STATE OF TENNESSEE
DEPARTMENT OF TRANSPORTATION
DESIGN DIVISION
NASHVILLE, TENNESSEE 37243-0348

INSTRUCTIONAL BULLETIN NO. 08-07

Regarding revised Guardrail Standard Drawings S-GR-11, S-GR- 22, S-GR-26, and
Cantilever Signal Support Standard Drawing T-SG-9.

STATE OF TENNESSEE
 DEPARTMENT OF TRANSPORTATION
 W-BEAM & THRIE BEAM BARRIER RAIL AND RUB RAIL ALTERNATES
 S-GR-11

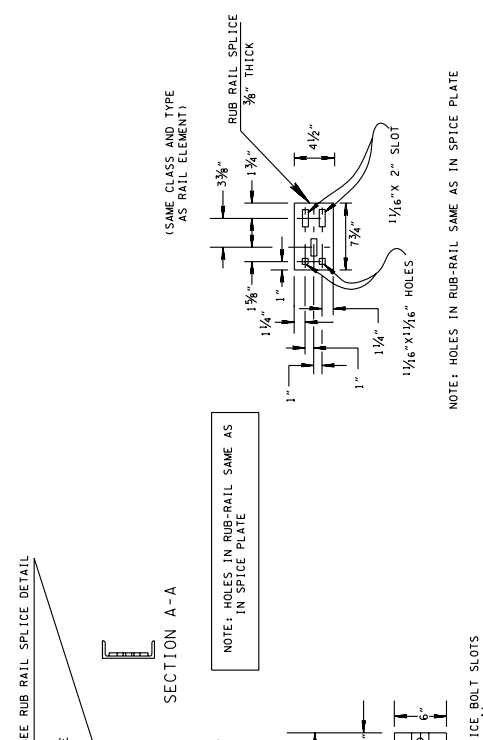
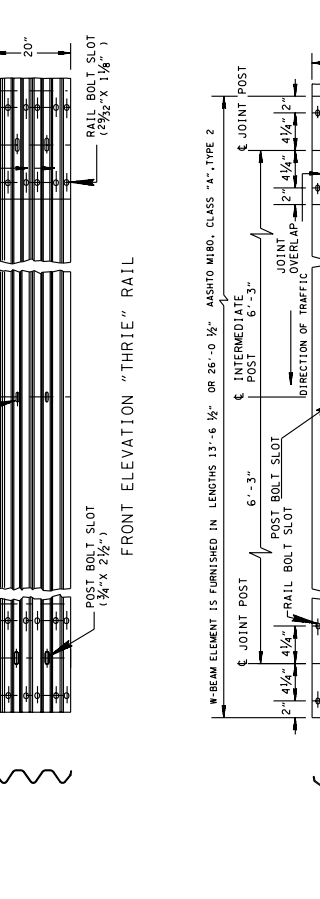
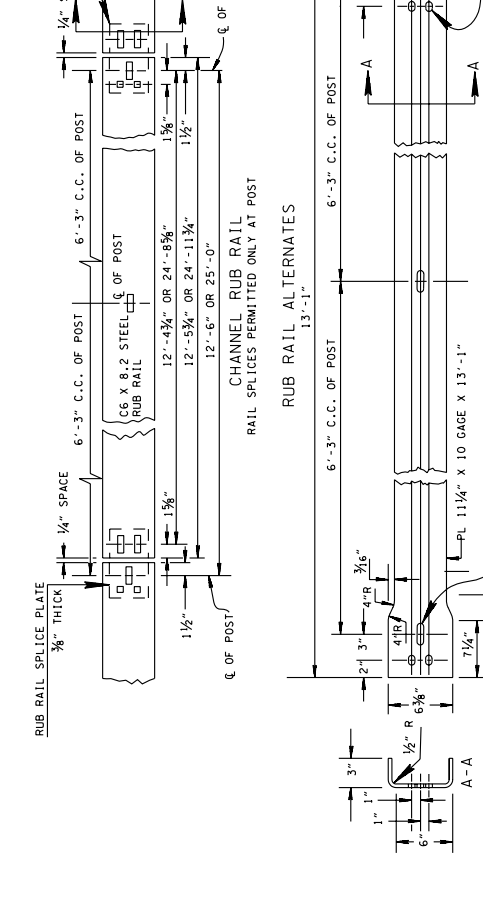
REV. 10-26-94: IN GENERAL NOTES
 CHANGED DRAWING NUMBER.
 REV. 1-19-95: IN GENERAL NOTE
 CHANGED DRAWING NUMBER.
 REV. 7-29-95: IN GENERAL NOTE
 ADDED ITEM NOS. 705-04.20 AND 705-04.21.
 REV. 5-27-95: IN GENERAL NOTE
 ADDED ITEM NO. 705-04.06.
 REV. 6-10-96: ADDED DIMENSION FOR WIDTH TO RUB RAIL SPLICE DETAIL.
 REV. 7-29-98: MODIFIED GENERAL NOTE
 REV. 9-5-98: MODIFIED GENERAL NOTE
 REV. 10-26-99: DELETED BACK UP PLATE DETAILS.
 REV. 9-5-00: IN GENERAL NOTES
 CORRECTED NOTE
 REV. 5-27-01: IN GENERAL NOTE TO CONCUR WITH NEW PAVEMENT SYSTEM.
 REV. 9-5-01: CORRECTED DESCRIPTION FOR ITEM NO. 705-04.07.
 REV. 9-11-02: DELETED ITEM NO. 705-01.02.
 REV. 9-5-03: CHANGED GENERAL NOTE
 DELETED GENERAL NOTE
 RENUMBERED REMAINING GENERAL NOTES.
 REV. 8-22-05: CHANGED GENERAL NOTES AND
 REV. 6-30-05: MODIFIED GENERAL NOTE
 REV. 11-26-07: REVISED STD. DIM. NUMBERS.

INSIDE ELEVATION OF GUARDRAIL

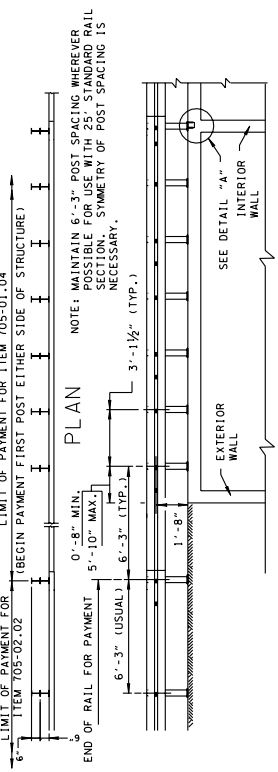
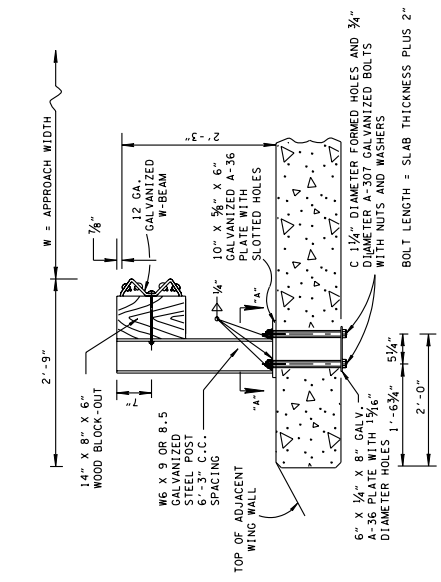
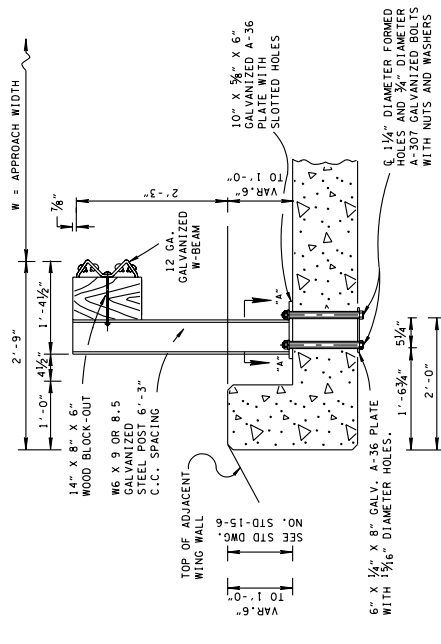
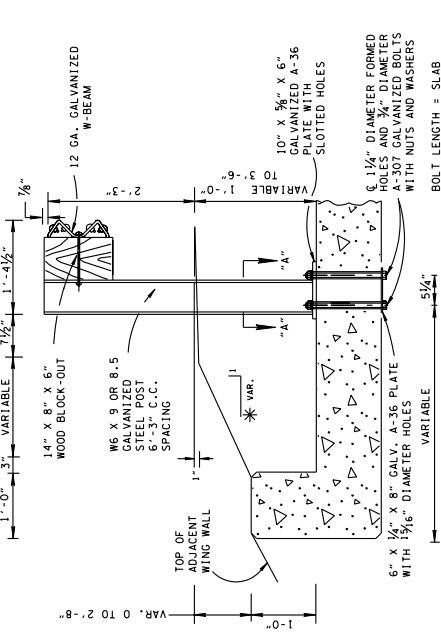
- REV. 9-5-97: MODIFIED INSIDE ELEVATION OF GUARDRAIL DETAIL.
- REV. 7-29-98: CHANGED STEEL WELDED TO TOP OF WOOD BLOCK-OUTS IN ALL DETAILS AND NOTES.
- REV. 5-27-99: RELOCATED 1 1/2" DIAMETER FORMED HOLES OUTWARDLY 1 1/2".
- REV. 10-26-01: ELIMINATED DETAILS FOR PRECAST CONCRETE DECK PANELS FOR HEIGHT OF FILLS OVER 1'-6". CHANGED DESIGN NOTE.
- REV. 4-15-02: CHANGED ITEM NO. 705-06-01 TO 705-01.04.
- REV. 11-26-02: ELIMINATED DETAILS FOR PRECAST CONCRETE DECK PANELS FOR HEIGHTS LESS THAN 1'-6". CHANGED TYPE OF CHER TO COMPLY WITH NEW STANDARD DRAWINGS STD-12-6 AND STD-15-7.
- REV. 11-21-07: REVISED GUARDRAIL POST SPACING.
- REV. 3-13-08: REVISED FILLED WELD SIZE BETWEEN POST/BASE PLATE.

- (1) GUARDRAIL POST SPACING SHALL BE REDUCED TO 3'-1 1/2" AT CONCRETE DECK ATTACHMENTS.
- (2) WHEN DEPTH OF FILL AT FACE OF GUARDRAIL EXCEEDS 3'-6" DELETE THE USE OF BOLTED BASE PLATES AND DRIVE POSTS.
- (3) THE USE OF PRECAST, PRESTRESSED CONCRETE DECK PANELS IN BOX AND SLAB TYPE CULVERTS IS PROHIBITED.
- (4) THIS RAIL SYSTEM HAS BEEN TESTED IN ACCORDANCE WITH THE CRITERIA SET FORTH IN NCHRP REPORT NUMBER 230, MARCH 1981, AND SUCCESSFULLY CONTAINED A 4,450 POUND VEHICLE AT A VELOCITY OF 61.8 MPH AND AN IMPACT ANGLE OF 25.3 DEGREES. REFERENCE REPORT FHWA/TX-86/64-405-2F, NOVEMBER 1986.
- (5) ANY REINFORCING STEEL THAT INTERFERES WITH THE 1 1/4" DIAMETER FORMED HOLES SHALL BE MOVED HORIZONTALLY TO PROVIDE A 1" MINIMUM CLEARANCE TO THE HOLE.

SLOTTED GUARDRAIL TERMINAL ANCHOR (TYPE 21)

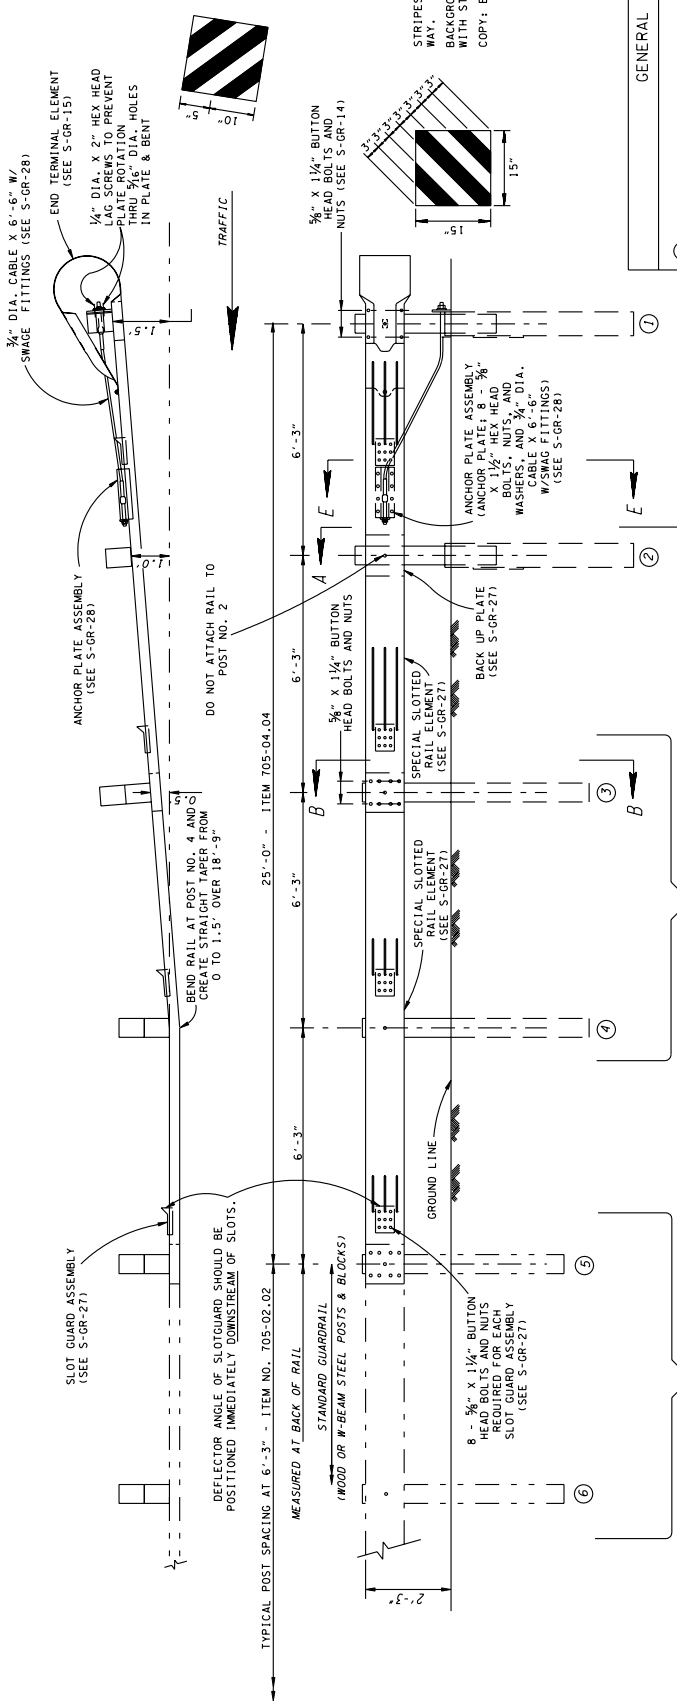
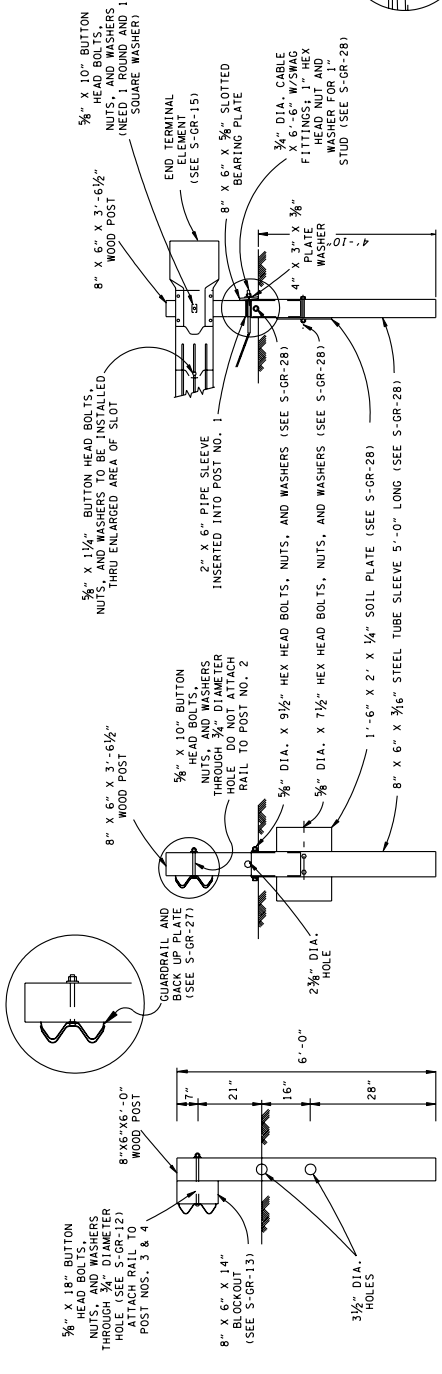
- REV. 12-18-95: REMOVED GROUND RAIL FROM BEARING PLATE AND MADE OTHER MINOR CHANGES.
- REV. 5-27-96: CHANGED DIAMETER OF HOLES IN 8" X 6" SLOTTED BEARING PLATE FROM $\frac{3}{8}$ " TO $\frac{1}{2}$ ".
- REV. 5-27-98: REPLACED SHELF ANGLE WITH BACK UP PLATE ON POST NO. 2.
- REV. 12-18-98: MODIFIED OLD BEARING PLATE TO BE INSTALLED WITH OLD BEARING NOTE (3) TO MAKE NEW GENERAL NOTE (2).
- REV. 5-27-01: CHANGED PAY ITEM NO. 705-04.21 TO 705-04.04. ADDED SPECIAL GUARDRAIL INSTALLATION NOTE.
- REV. 11-01-01: CHANGED SPECIAL GUARDRAIL INSTALLATION NOTE FOR SPECIAL INSTALLATION NOTE.
- REV. 9-25-01: CHANGED HEADING FOR SPECIAL INSTALLATION NOTE.
- REV. 10-26-07: REMOVED SPECIAL INSTALLATION NOTE. ADDED GENERAL NOTE (1).
- REV. 3-15-08: REMAINED.

VIBRATION DAMPER PLATE DETAILS

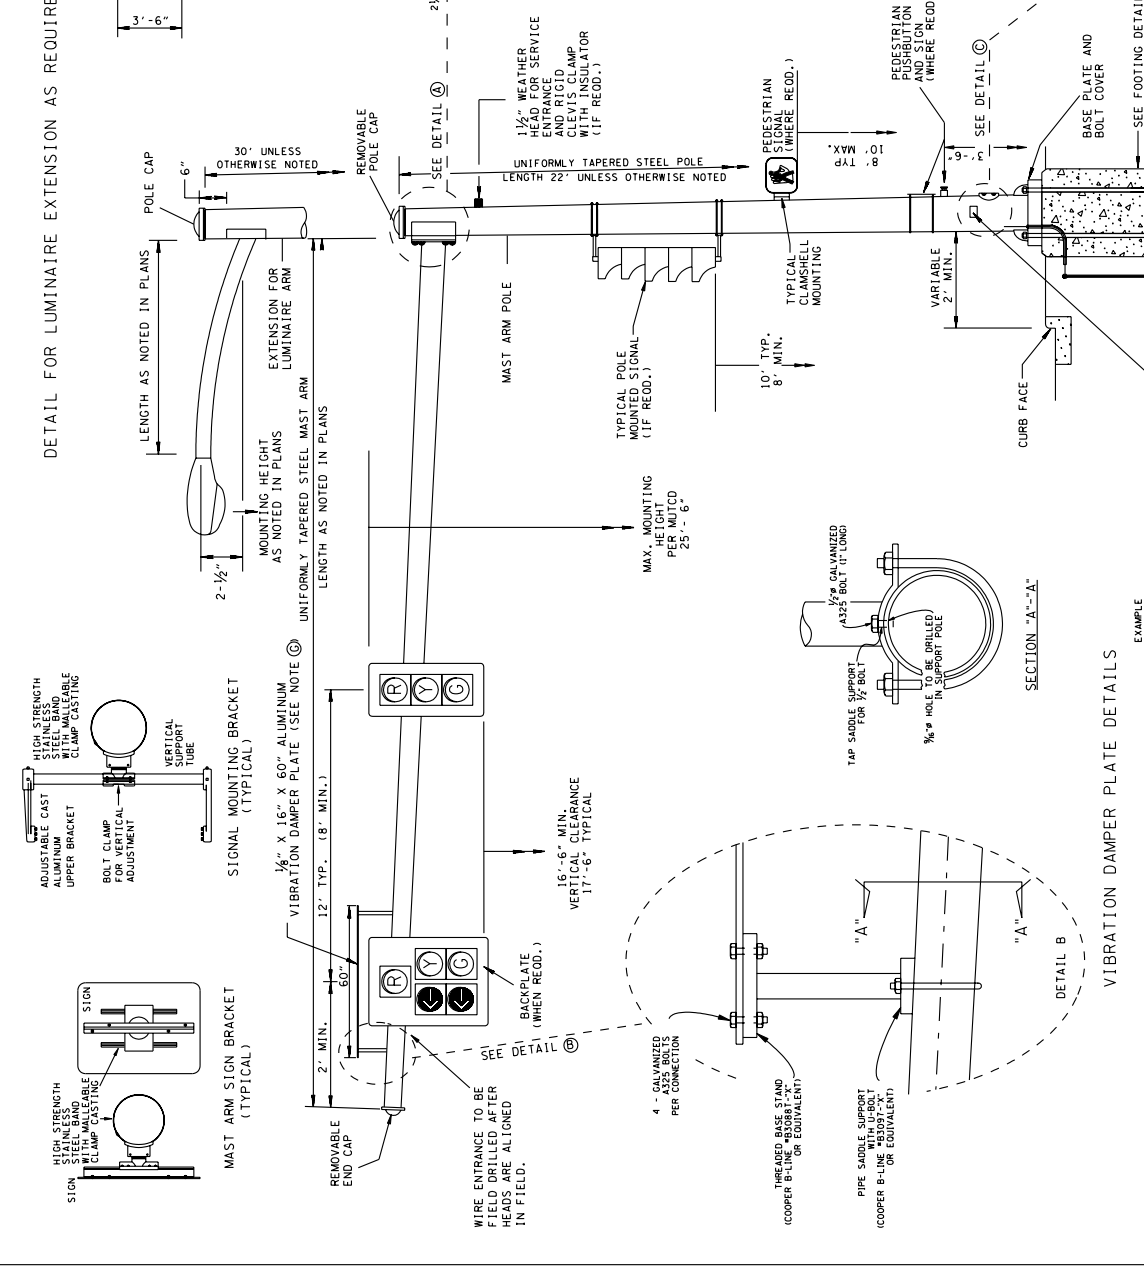
- REV. 7-29-92: DELETED CLAMP AND CLEVIS MOUNT FOR SIGNAL HEADS.
- REV. 7-29-96: REDREW SHEET ON CADD AND MADE MINOR CHANGES.
- REV. 12-16-03: REDREW SHEET, REV. SIGNAL MOUNTING BRACKET, ADDED SIGN MOUNTING BRACKET, ADDED SIGNAL MOUNTING HEIGHT FOR SIGNAL HEADS AND ADDED HAND HOLE DETAIL.
- REV. 7-29-04: REDREW AND REDDESIGNED SHEET.
- REV. 11-16-07: ADDED VIBRATION DAMPER PLATE DETAILS.

- PEDESTRIAN SIGNAL HEADS TO BE CLAMHELL MOUNTED UNLESS OTHERWISE SHOWN ON PLANS.
 - VIBRATION DAMPER PLATE SHOULD BE INSTALLED ON ALL MAST ARMS 50' OR LONGER AND ALWAYS BE INSTALLED AT OUTSIDE TIP.
